Certificate of Appropriateness

3316 W. MC KINLEY BL., Cold Spring Park Historic District, Will Sherard, Owner

Remove existing porch deck, columns, railings and guardrails. Install new porch deck, handrails, guardrails posts and skirting.

PTS ID 73501 COA, porch posts, railings, guardrails, deck and skirting.

3316 W. McKinley Blvd.

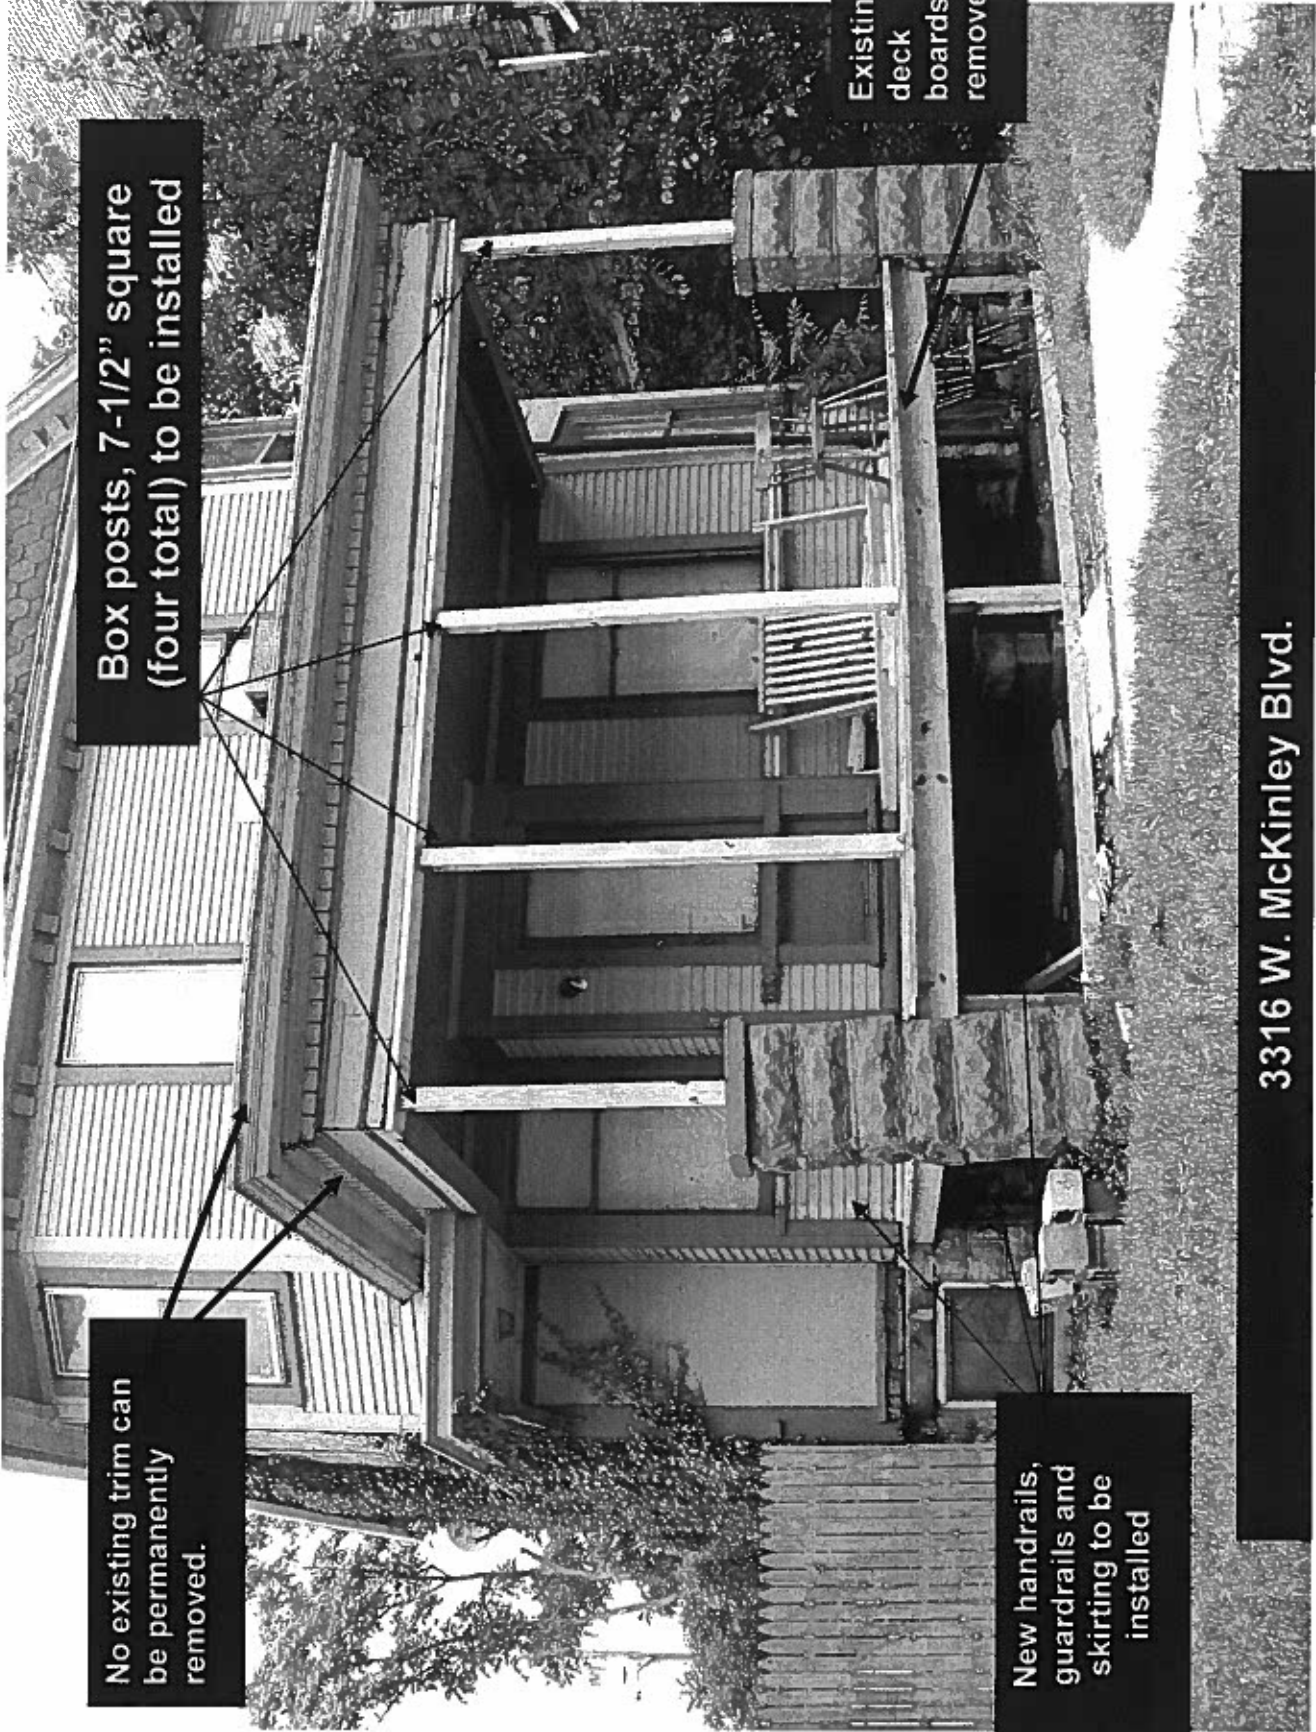
No existing trim can be permanently removed.

Box posts, 7-1/2" square (four total) to be installed

Existing deck boards to be removed

New handrails, guardrails and skirting to be installed

Astragal

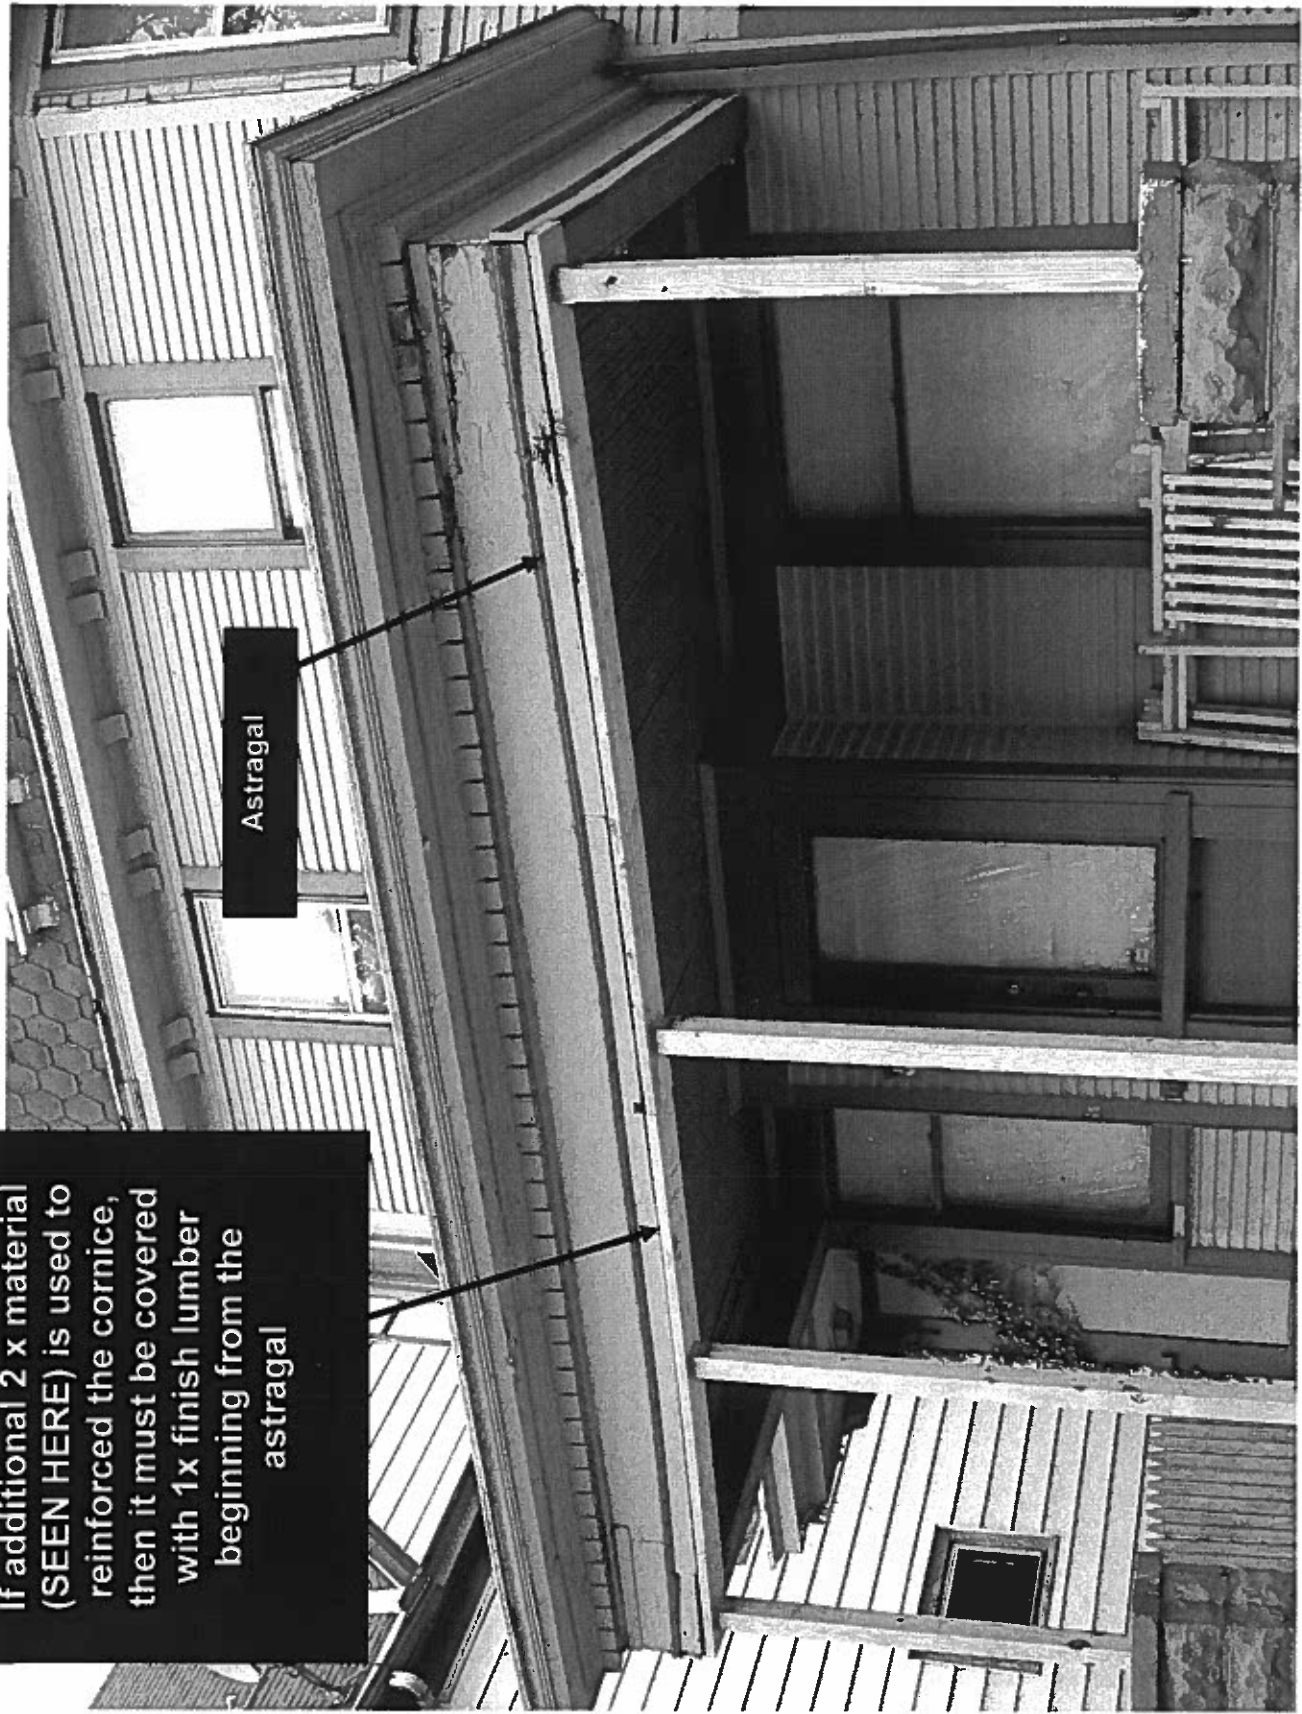
If additional 2 x material (SEEN HERE) is used to reinforced the cornice, then it must be covered with 1x finish lumber beginning from the astragal

Traditional Porch Floors

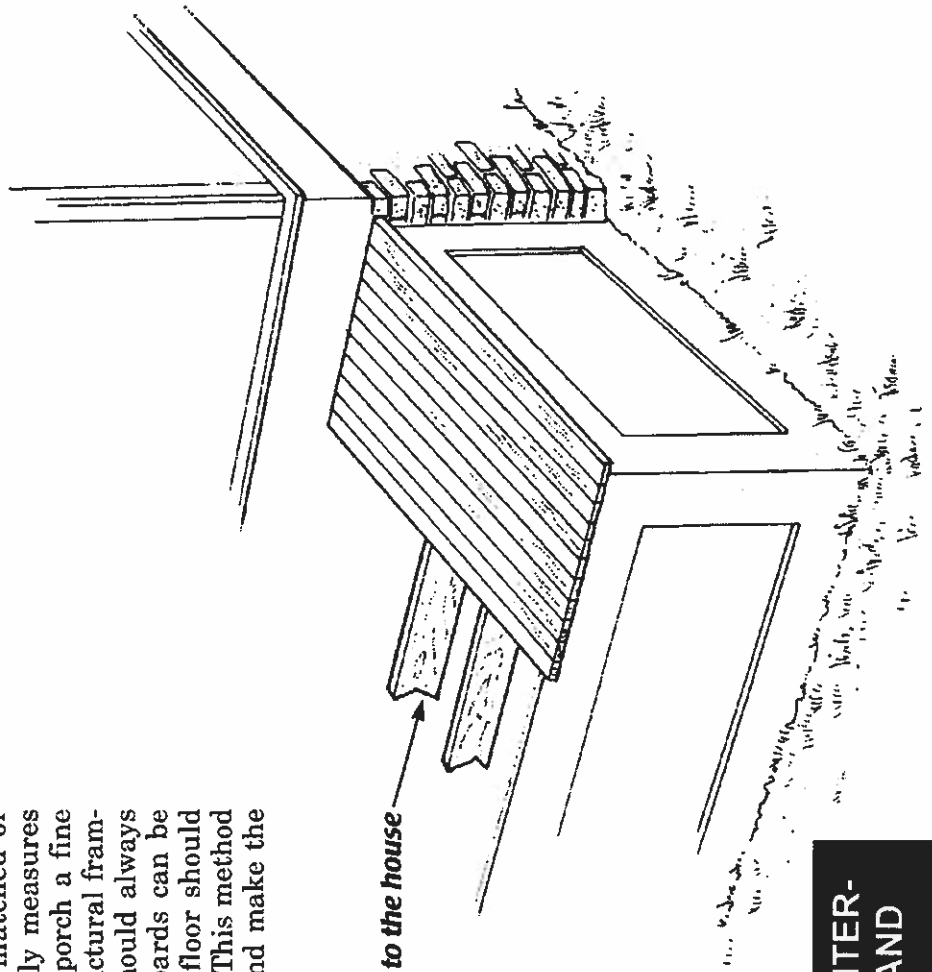
Porch floors should be constructed of center matched or tongue-and-groove wooden flooring, which typically measures 2-1/4" wide by 3/4" thick. This flooring gives the porch a fine finished appearance. The joists, which are the structural framing members to which the flooring is attached, should always be run parallel to the house so that the floor boards can be installed perpendicular to the house. The porch floor should also be very slightly pitched away from the house. This method of construction for a porch floor will shed water and make the porch last longer.

Joists parallel to the house

Center match or tongue-and-groove flooring

PORCH DECK MUST BE MADE OF CENTER-MATCH, ALSO KNOWN AS TONGUE AND GROOVE MATERIAL

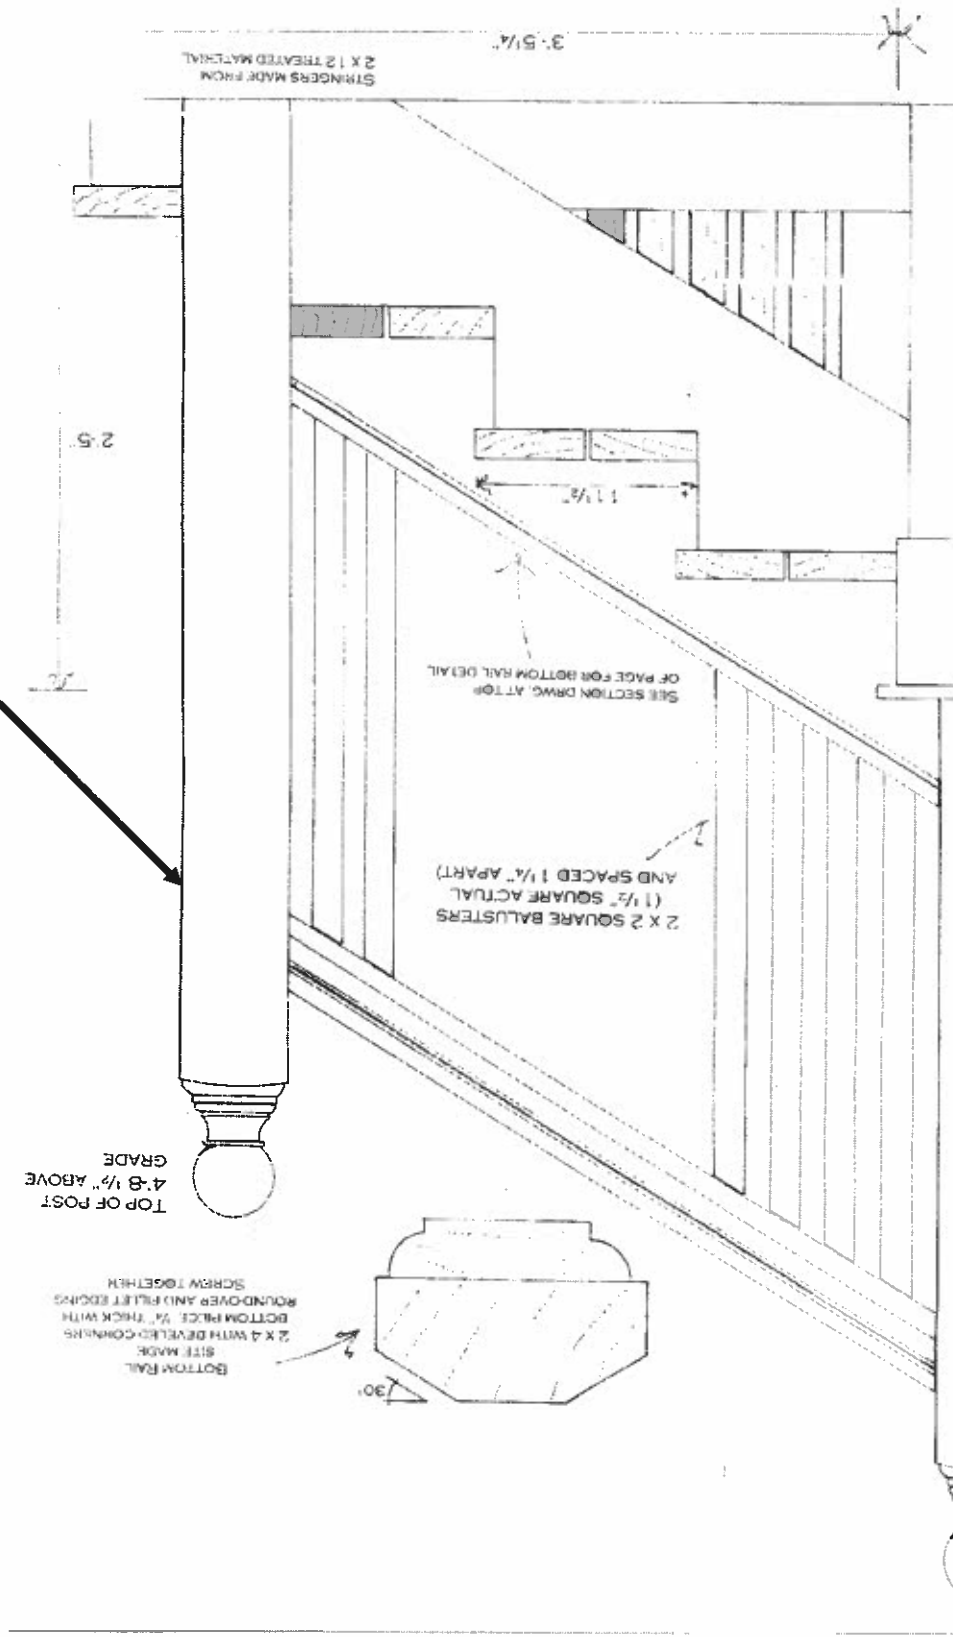
Please note the design for the optional 5-1/2" square box post and top elsewhere on this certificate.

Porch railings and guardrails to be constructed according to this plan. Slats in skirting are 1-3/4" wide and spaced 3/4" apart. As an alternate to the vertical slats, a skirting infill of lattice may be substituted. 2 x 2 square balusters are spaced 1-1/4" apart

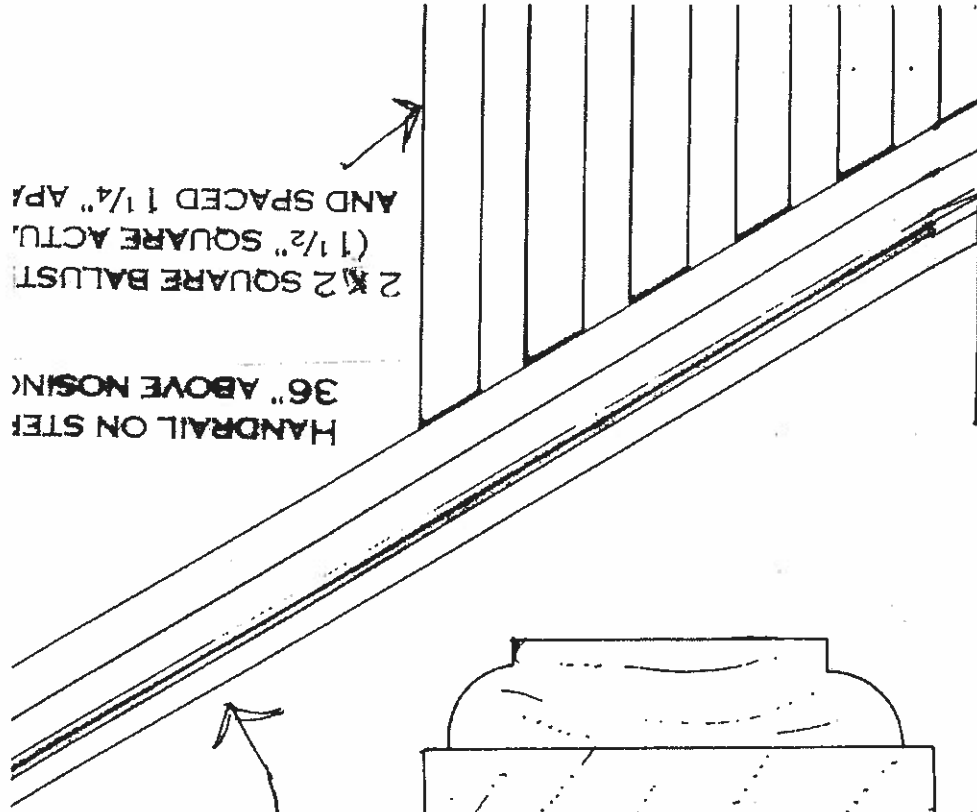
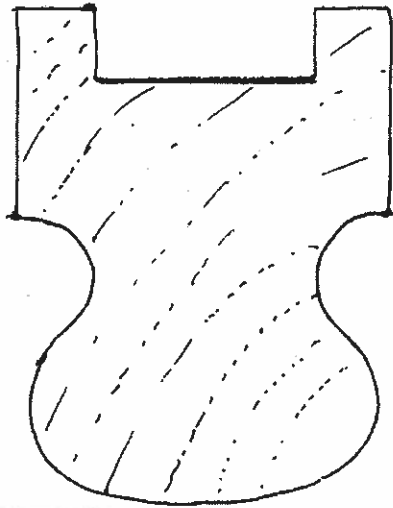
HANDRAIL ON STEPS
36" ABOVE NOSING
2 X 2 SQUARE BALUST
(1 1/2" SQUARE ACTU.
AND SPACED 1 1/4" APART)

FROM RAIL
THE MADE
BEVELED CORNERS
3/4" THICK WITH
AND FILLET EDGING
W TO
ST
OVE

GRASPABLE HANDRA
CROWN SPECIALTY MOULD
#HR-548
WWW.CROWN.SPECIALTY.MOULD
608-290-1338
MILTON, WI

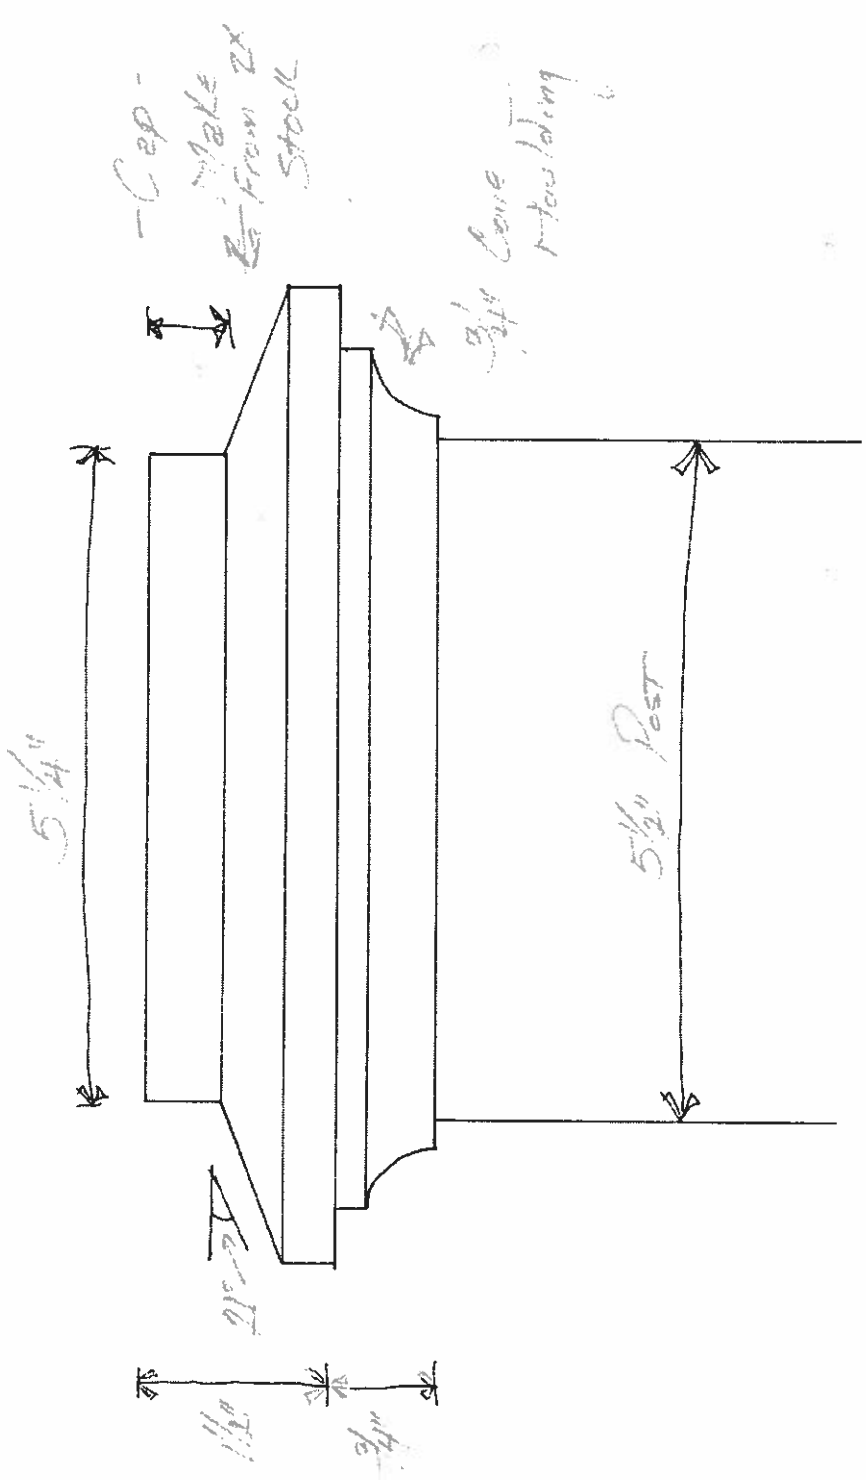
Section off handrail and bottom rail for porch. Bottom rail made from a 2x4 (clear) stock, beveled 30 degrees at the corner. A 1 x 3 with round-over and fillet to be screwed to the bottom

Optional square box post and top for newel posts on porch steps.

Porch Skirting

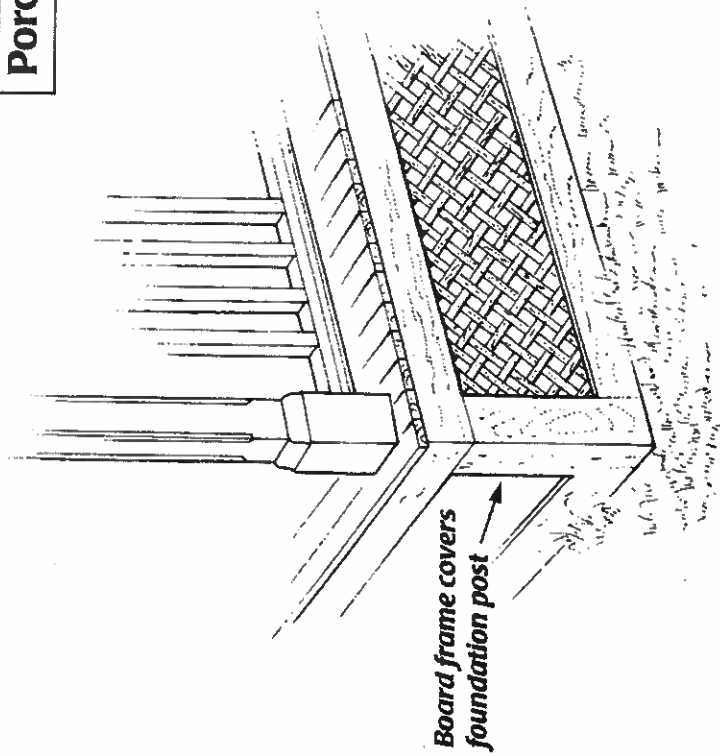
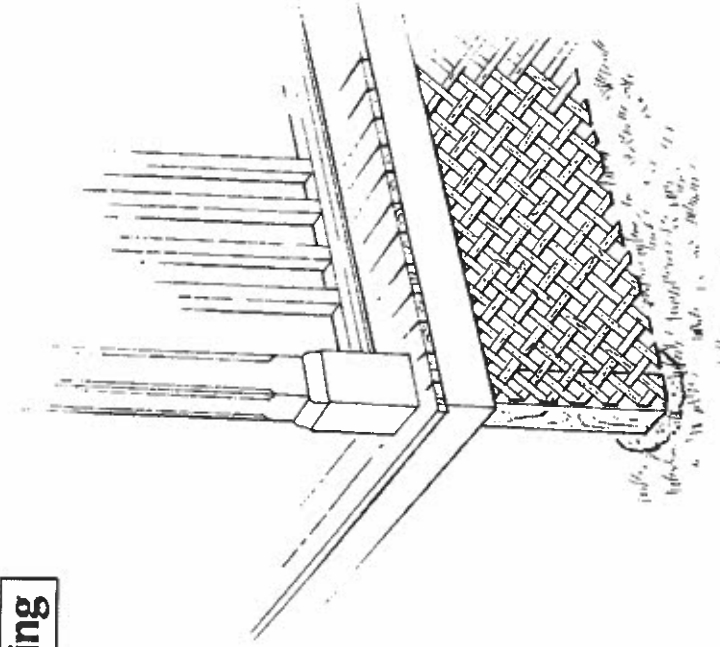
Skirting, such as this lattice panel, enclosed the area beneath the porch floor. It should always be installed with a continuous board frame around it that is wide enough to cover the rough framing lumber that supports the porch deck.

Do not install a lattice skirting without a frame around it. The rough framing lumber that supports the porch will show through and the raw edges of the lattice look unfinished.

Slats of 1-3/4" wide and spaced 3/4" apart may be substituted for the lattice work, but in either case a full frame surround as pictured at left is required.
